Memo

To: Brad Sedgwick
From: Pat O’Mahony, Associate Planner; 910-341-0189
CC: File;
Date: 11/18/2020
Re: Nourish NC TRC Rev. 3

Departure Sight Triangles (Stop-Controlled)

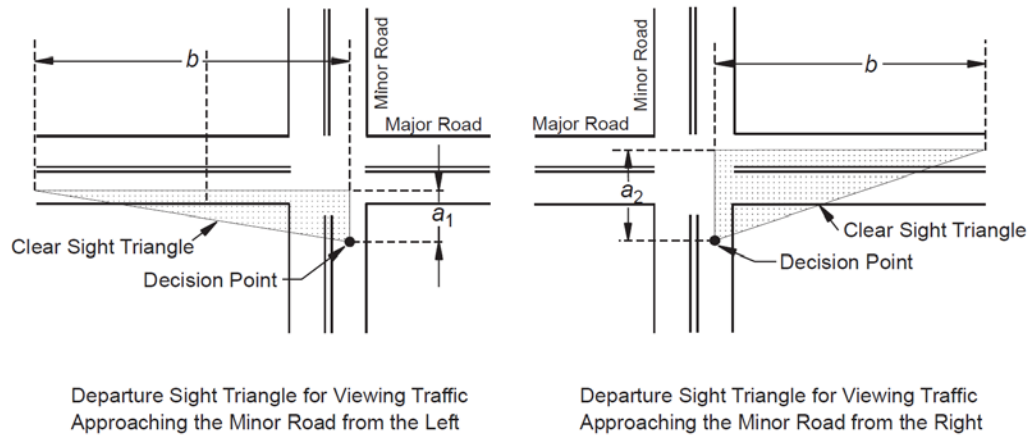
1. Sheet C1 has a not for Table 3-1 green book which is a stopping sight distance, and it is not a relevant sight distance in this case. Please revise according to below.
2. Market St is a major thoroughfare [Chap VII (C) (2) (a) of CofW Tech Stds]. In accordance with the City Code, sight distances along thoroughfares must be calculated in compliance with the AASHTO requirements. [Chap VII (C) (1) of CofW Tech Stds] [Sec.18-556 CofW LDC].
3. Show the departure sight distances with dimensions for the intersections on site and landscape plans.
4. Refer 'AASHTO A Policy on Geometric Design of Highways and Streets', Chapter 9.5.2 Departure Sight Triangles. Here minor road is driveway. Since it is an apron style driveway it is considered as a stop-controlled, regardless of stop sign.

5. Show departure sight distances as explained above as well as 20'x70' SDT as per City standards.
